Docket Item #12-A&B
SUBDIVISION #2004 - 0011 (12-A)
DEVELOPMENT SITE PLAN #2004-0013 (12-B)
OLD CLUB

Planning Commission Meeting
December 7, 2004

ISSUE: Consideration of a request for a development site plan and subdivision with modifications, for the redevelopment of the existing Old Club Restaurant building and the adjacent site to include four condominium units in the existing building, four new townhouses on Gibbon Street and detached garages.

LOCATION: 555 South Washington Street, 711-715 Gibbon Street and 798 Wilkes Street

Existing Outlot

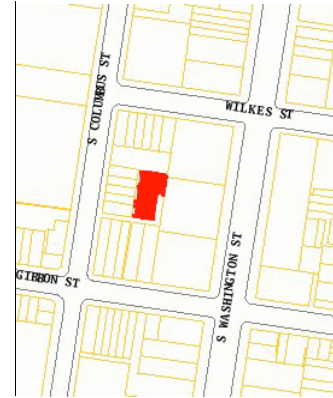
There is an existing outlot (Lot 705) to the north of the four proposed townhouses. Because the outlot is an existing condition and because the lot is being used solely for parking, staff supports the use of the this existing outlot. The proposal for parking and detached garages within the central portion of the block is characteristic of the traditional development pattern within Old Town. However, staff is recommending a condition requiring deed restrictions on this lot which will prohibit future subdivision, additional structures or future development on this lot. The responsibility of the maintenance of this surface parking lot, detached garages and proposed alley will be the responsibility of the condominium and townhouses associations.

2. Lot 705 as depicted in the subdivision plan shall be limited to the uses of parking and access to the parking and shall be designated as a common area owned by the condominium and townhouse property owners. The deed for the outlot shall contain deed restrictions that shall prohibit the lot from being sold as a separate lot of record and shall prohibit all structures or uses other than the detached garages depicted on the preliminary plan and shall prohibit future subdivision and cannot be sold as a separate lot of record. The applicant shall disclose to all prospective buyer(s) through the sales literature and documents, sales contracts etc. the maintenance requirements, current and future access rights potential liability, and that the outlot cannot be developed or sold as a separate lot of record and shall include the same in the Condominium and Homeowners Association documents. The deed restrictions shall be approved by the City Attorney prior to the release of the subdivision plan. (P&Z)
